PLANNING, ZONING, & BUILDING DEPARTMENT
PZ&B Staff Combination Memorandum: Architectural Commission and Town Council

SUBJECT: ARC-23-107 (ZON-23-077) 162 E INLET DR (COMBO)

MEETING: SEPTEMBER 27, 2023

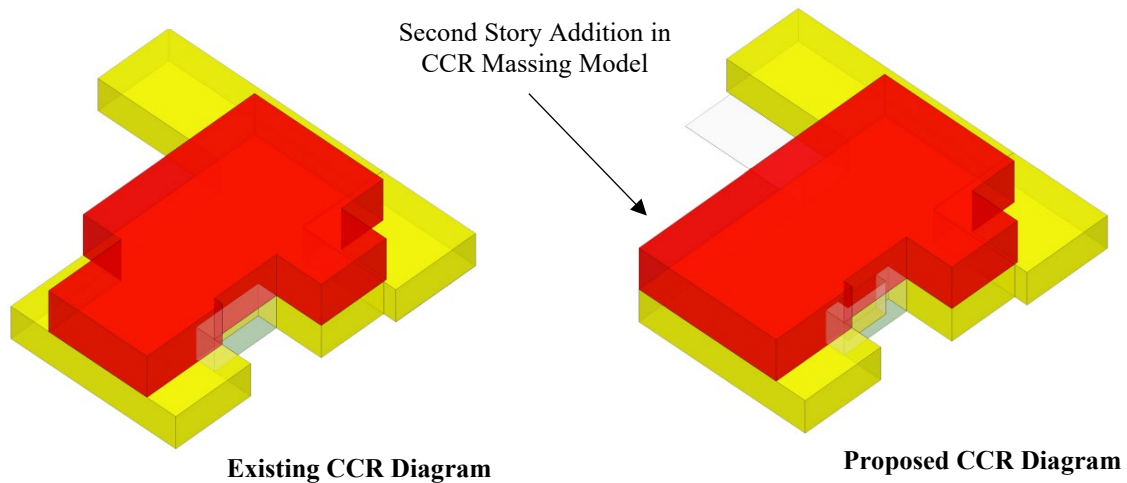
A preliminary review of the project indicates that the application, as proposed, is inconsistent with the Town zoning code and requires one (1) variance to increase the already non-conforming Cubic Content Ratio (CCR) beyond what code permits, the maximum of which for this sized (10,848 SF) R-B zoned lot is 3.99.

The two-story single-family residence at 162 E Inlet Drive was constructed ca. 2004 on a 10,848 SF parcel. The current application requests to construct two enclosed additions and a rear awning
